SITE INSTRUCTION #5**Project Name: Hampton Manor (25 Baker Hill Boulevard) - Stouffville****Project Number: 20140490****Vince Staffieri****September 12, 2017****Royal Pine Homes****3550 Langstaff Road, Suite 200****Woodbridge, Ontario L4L 9G3****via email: vince@royalpinehomes.com**

A. REFERENCE:

- .1 Drawings S1-02, S1-06 AND S8-02.

S1-06

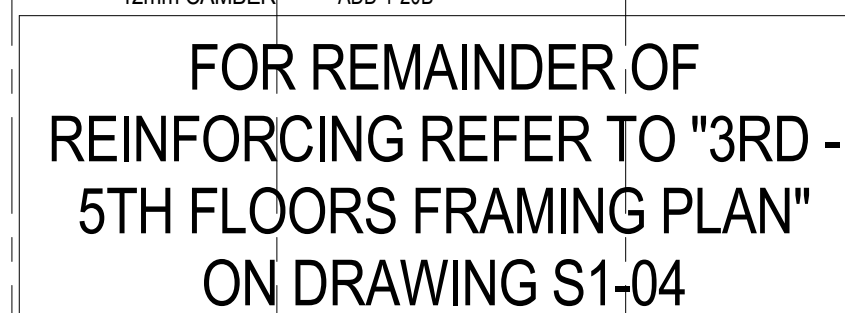
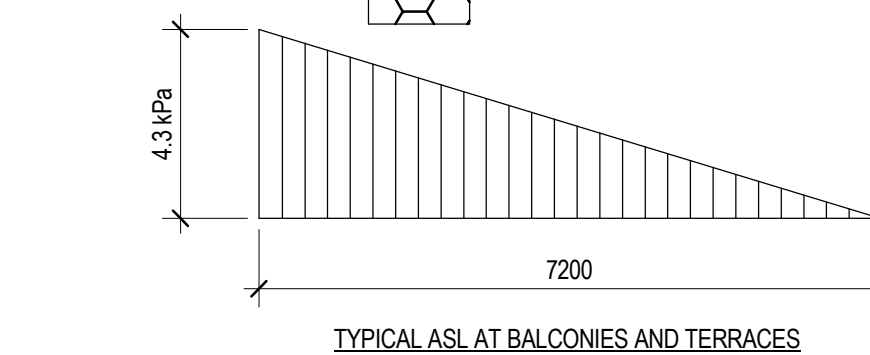
- .1 Placement of reinforcement at Ground Floor is clarified as indicated on Drawing S1-02.
- .2 At level 7, revise section 2/S1-06 to suit pockets for precast panels.
- .3 Typical detail CS02B/S8-02 is revised to clarify extent of reinforcement.
